# Supporting Documentation for Application 17/2779/NMA1

The purpose of this document is to highlight the differences between the approved plans and the submitted plans. Our Cover Letter highlights which new elements we are seeking approval for. Importantly this document highlights the errors made when drawing up the original (now approved) plans relating to the existing structure.

Latchmere House Refurb Latchmere Lane Kingston KT2 5NX

GA Elevations East Elevation

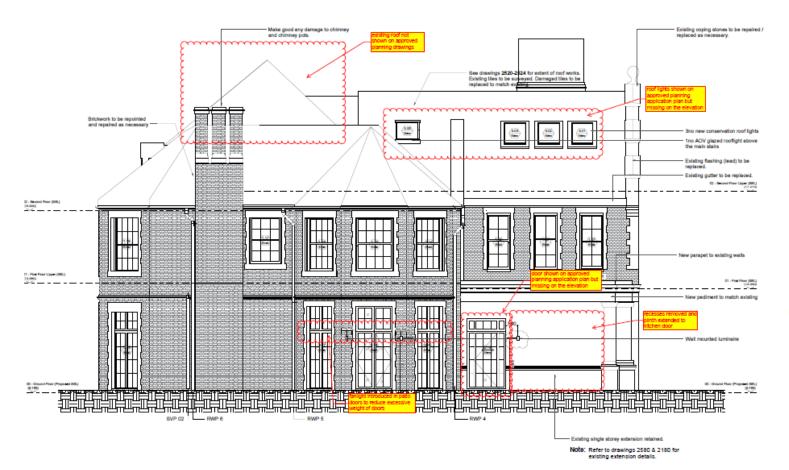
New RWP to be replaced with existing

New roof 150mm cast aluminium gutters and an outlet size of 100mm.

GA Elevations Elevation 4

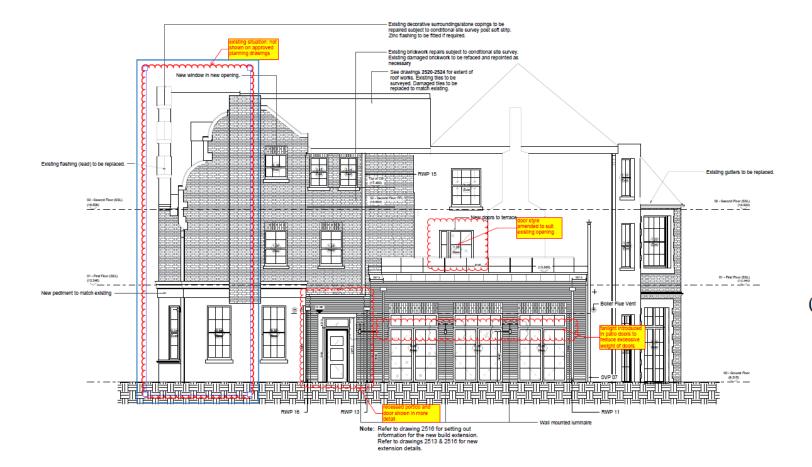
$\blacksquare$	
-	External Wall lights position & type changed	23.04.19	PN	PN
u	External wall lights added	15.03.19	PN	PN
0	2.14 & 2.15 Window CIII arrended to suit Client comments	18.01.18	DM	T.
0	RWP 15 & 16 added	05.12.16	PN	PN
•	New pediment. Dry riser outlet. Rooflights & additional window bars	22.11.18	PN	PN
	Construction Issue	23.10.10	PN	PN
RW	Description	issued	Dwn	Ch
